**MEMORANDUM**

SUBJECT: Final OP Report for Z.C. 06- 14 B, Modification Request for Washington Gateway PUD
Square 3584, Lots 23, 811 – 813, at Florida and New York Avenues

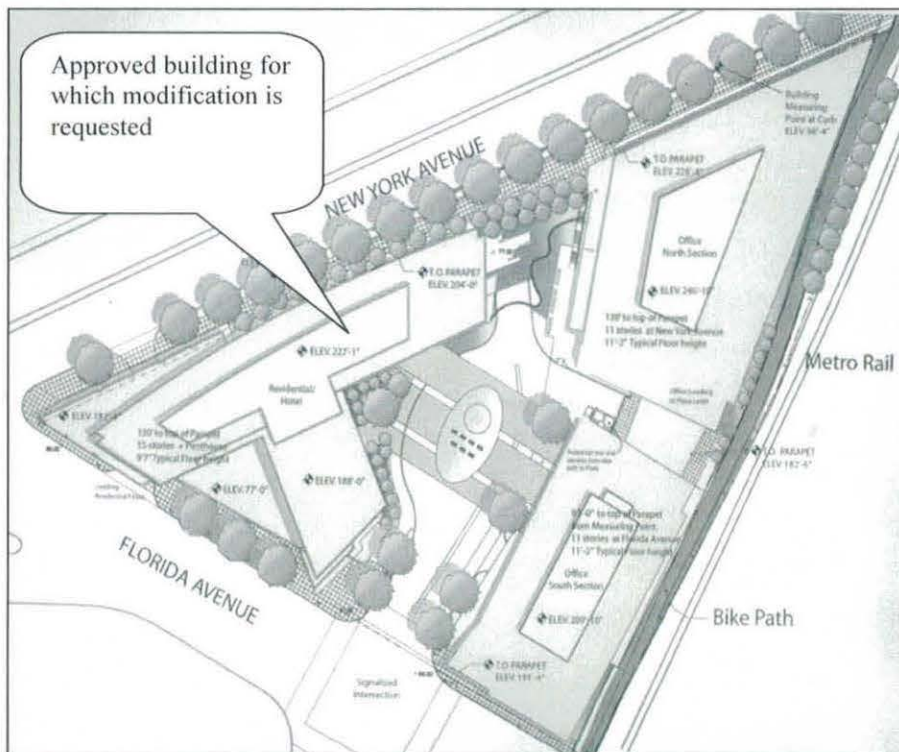
The PUD is on a triangular 3.1 acre site bounded by New York and Florida Avenues and the Metropolitan Branch (bicycle) Trail (MBT) adjacent to the right of way of Metrorail's Red Line, as shown on the approved site plan to the left. It is approved to consist of:

- A. One office building on the eastern side of the site.
- B. A vertically-divided residential and hotel building, with separate entries, on the northwestern side of the site.
- C. A landscaped central plaza and significant upgrades for the adjacent portion of the Metropolitan Branch Trail.

The approved design is modern, with glass curtain walls, aluminum and masonry. The site plan is intended to suggest the extension of the existing street grid, and would be open to the public from all three sides.
